**Re: 3 Hillfield Road Review of Daylight and Sunlight**

As requested, I provide below our professional opinion on the likely impact of your proposed development at 3 Hillfield Road on the daylight and sunlight within the ground floor of 5 Hillfield Road. This review has been based upon scheme drawings provided by Elevations Ltd. received 15<sup>th</sup> July 2020, aerial photography and site photography. The drawings compare the permitted development scheme at 3 Hillfield Road, currently under construction, with the proposed development. No quantitative analysis has been undertaken in the preparation of this letter and so the comments are indicative only.

**Figure 2: 3 Hillfield Road Proposed West elevation**

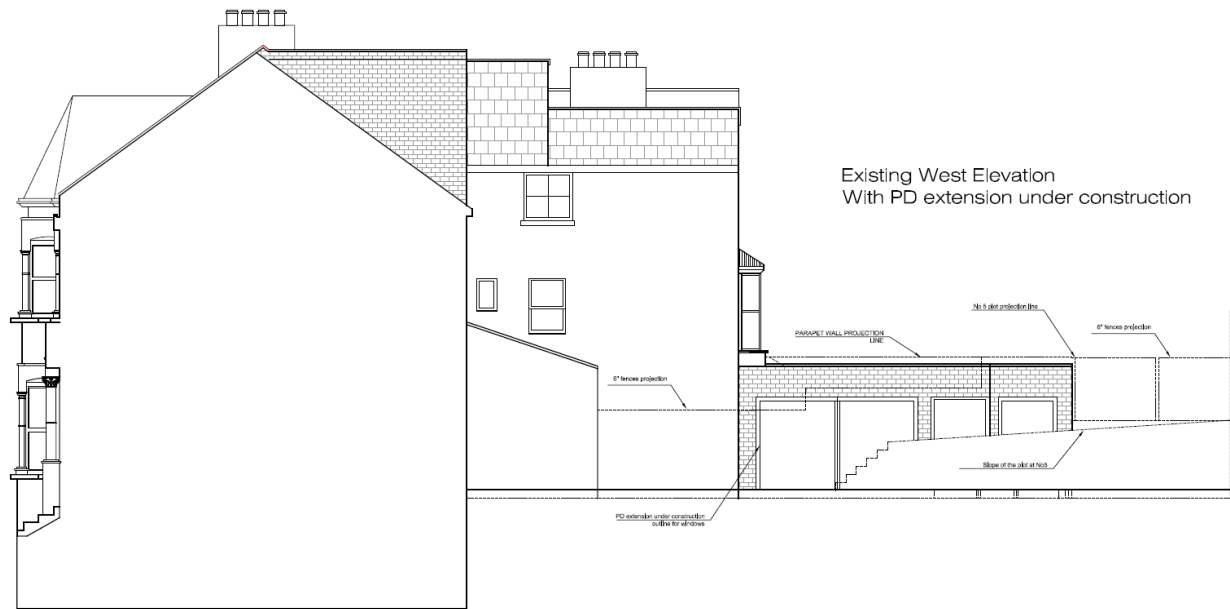
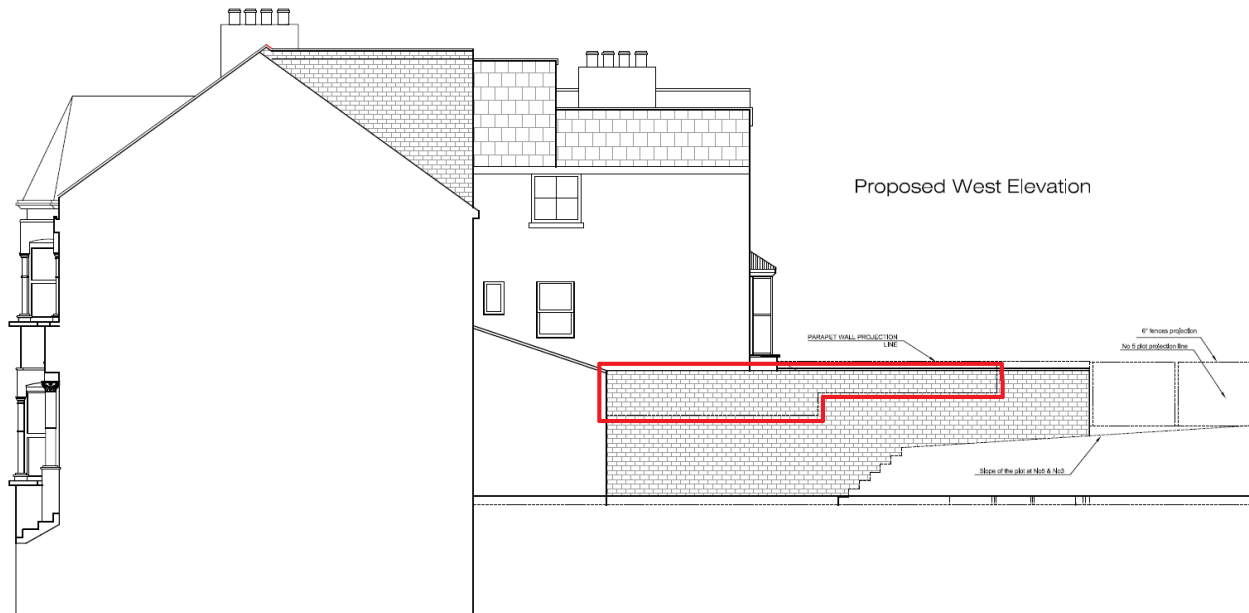
The existing West elevation of the 3 Hillfield Road, including the under construction permitted development, can be seen below in Figure 1. The proposed West elevation is shown in Figure 2. The additional massing of the proposal that can be seen by the ground floor windows within No. 5 is shown below in Figure 2 outlined in red. The windows within No. 5 above the ground floor are too high and have not been considered further.

Window 1 in photo 1 above either serves a bathroom or potentially a kitchen. All the windows above this are served by soil pipes suggesting this is more likely to be a bathroom. If this window does serve a bathroom the BRE guidelines consider bathrooms less sensitive to daylight and sunlight and do not require that they are considered. If this window serves a kitchen, it faces the existing massing of No. 3 and much of the additional massing proposed will cause no additional obstruction to daylight. In our opinion, there will likely be little alteration to the daylight available to this window.

Window 2 in Photo 2 likely serves a bedroom or living room, this window faces north towards the rear of the property gaining most of its daylight from that direction. The additional obstruction to daylight would be set of to the side of the window causing a lesser reduction. A proportion of this additional obstruction will also be in the shadow of the existing building and permitted development with the proposal therefore causing a lesser obstruction to daylight.

When considering daylight there are 2 windows that have been considered. One of these windows faces West toward No. 3 and the additional massing of the proposal would mostly be below the existing obstruction of No.3 and any additional reduction in daylight would be small. The second window faces North with the proposed additional obstruction off to one side causing a lesser reduction to daylight.
